CITY OF ALBUQUERQUE

June 3, 2022

Re: Odacrem Coffee Shop
1108 Broadway Blvd. NE
Traffic Circulation Layout
Architect's Stamp 04-28-22 (J14-D200)

Based upon the information provided in your submittal received 05-27-22, the above referenced plan cannot be approved for Building Permit until the following comments are addressed:

AS-1.0

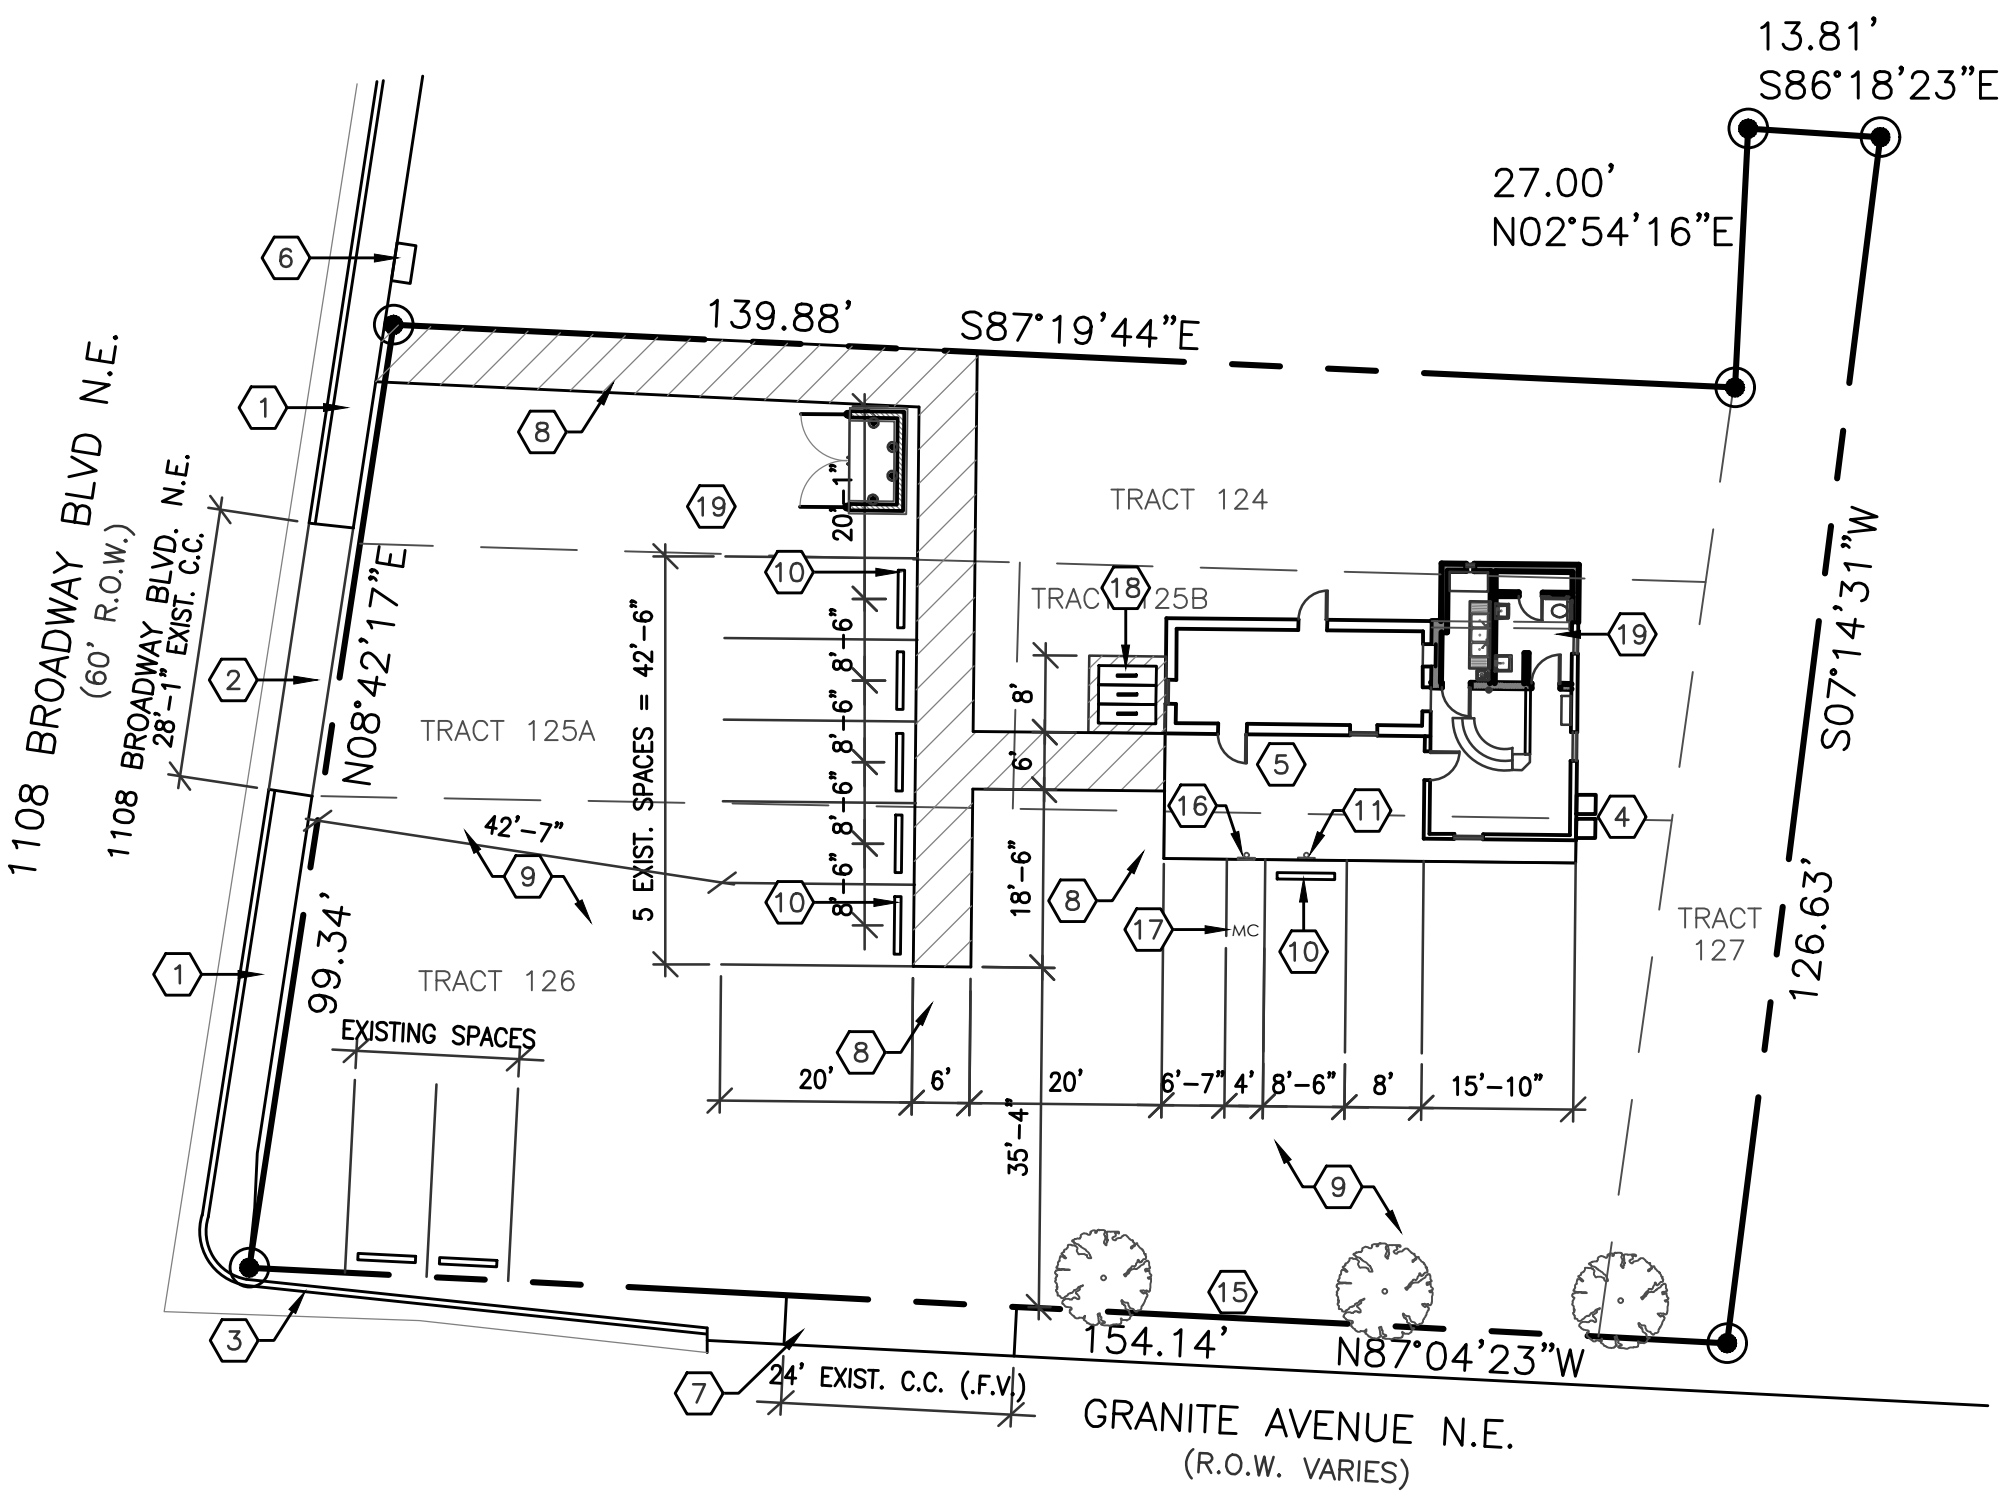
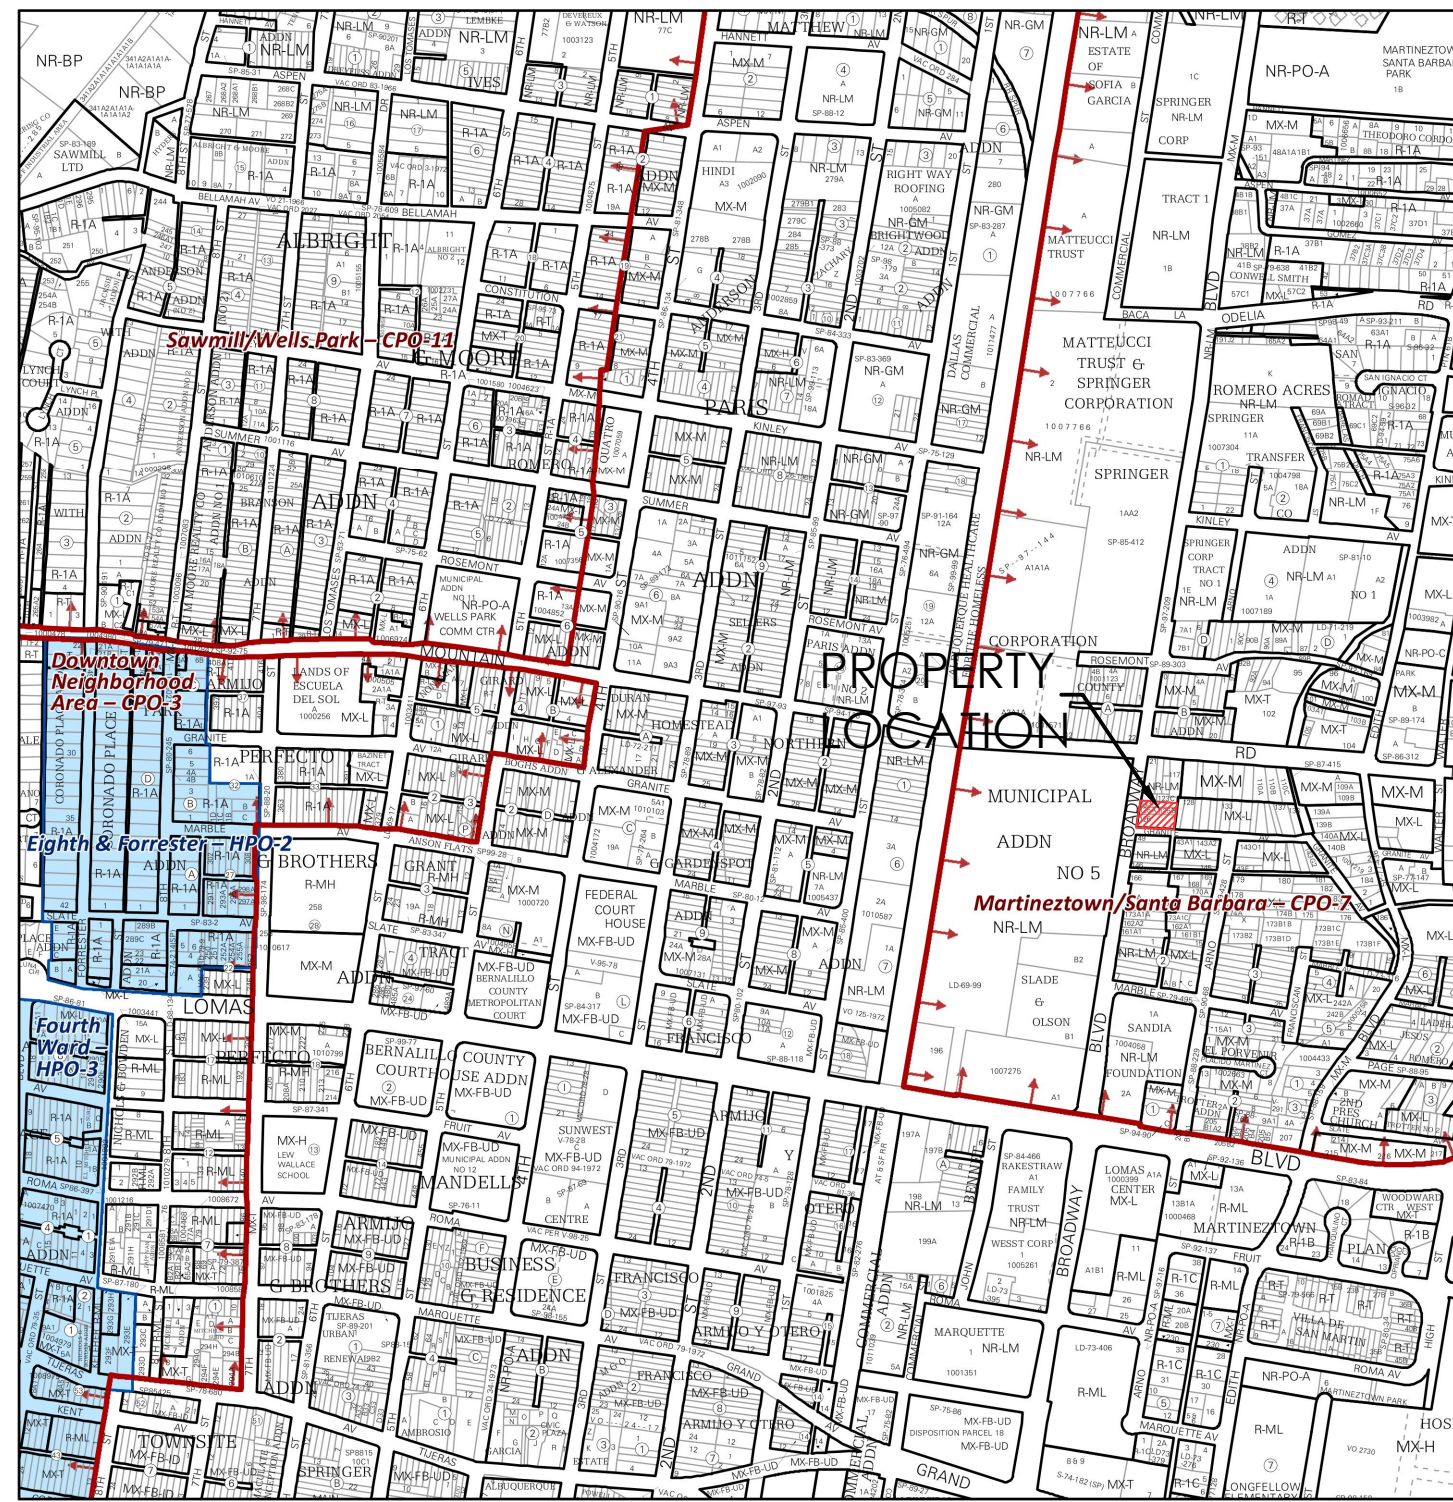
1. List the number of Bicycle parking spaces required by the IDO.
2. Please define the property line. GIS shows different lot lines, please verify.
3. Provide access easement with Tract 127, Tract 124, 125A, AND 126.

4. Granite Ave. Frontage:
 - Provide sidewalk per COA std dwg 2430 and curb and gutter per COA std dwg 2415.
 - For sidewalk waiver please contact Jeanne Wolfenbarger jwolfenbarger@cabq.gov (505-924-3991).

- Drivepad needs to build per city requirement, and should be ADA compatible.
5. Drivepad off Broadway needs to be modified to meet COA and ADA requirements.

6. The Ramp at the corner of Broadway and Granite is not ADA compatible. Please modify it. Also, a minimum 4 ft wide pedestrian path should be shown around the pole; show this dimension on the site plan to ensure that a minimum 4ft wide path is obtained.

7. Provide the dimensions for the existing parking spaces.
8. Please identify all existing buildings, doors, structures, sidewalks, curbs, drive pads, wall and anything that influences the parking and circulation on the site.

9. Identify the right of way width, medians, curb cuts, and street widths on Granite Ave. NE.
10. Please list the width and length for all existing and proposed parking spaces. Some dimensions are not shown.

12. ADA parking spaces should be concrete or pavement.
13. The ADA accessible spaces must include an access aisle. Van accessible aisles should be 8ft wide; all others should be 5ft wide.

14. The ADA accessible parking sign must have the required language per 66-7-352.4C NMSA 1978 **"Violators Are Subject to a Fine and/or Towing."** Please call out detail and location of signs.

15. The ADA access aisles shall have the words **"NO PARKING"** in capital letters, each of which shall be at least one foot high and at least two inches wide, placed at the rear of the parking space so as to be close to where an adjacent vehicle's rear tire would be placed. (66-1-4.1.B NMSA 1978)

16. ADA curb ramps must be updated to current standards and have truncated domes installed.
17. Provide ADA and Motorcycle face sign details.
18. Show all drive aisle widths and radii. Some dimensions are not shown.

20. Per the IDO, a 6 ft. wide ADA accessible pedestrian pathway is required from the public sidewalk to the building entrances. Please clearly show this pathway and provide details.
21. Per DPM, a 6 ft. wide ADA accessible pedestrian pathway is required from the ADA parking stall access aisles to the building entrances. Please clearly show this pathway and provide details.
22. ADA accessible pedestrian pathway should not be placed behind parking space or adjacent to a vehicular way. Vehicle and pedestrian/wheel chair conflicts should be avoided as much as possible.
23. Refuse vehicle maneuvering shall be contained on-site. The refuse vehicle shall not back into the public right of way. provide a copy of refuse approval.
24. A hard driving surface will be required for the ADA parking spaces.
25. Please provide a sight distance exhibit

26. Show the clear Intersection Distance sight triangle for Broadway Blvd. and add the following note to the plan: "Landscaping and signage will not interfere with clear sight requirements. Therefore, signs, walls, trees, and shrubbery between 3 and 8 feet tall (as measured from the gutter pan) will not be acceptable in the clear sight triangle.

27. Show the clear sight triangle for Granite Ave. and add the following note to the plan: "Landscaping and signage will not interfere with clear sight requirements. Therefore, signs, walls, trees, and shrubbery between 3 and 8 feet tall (as measured from the gutter pan) will not be acceptable in the clear sight triangle.
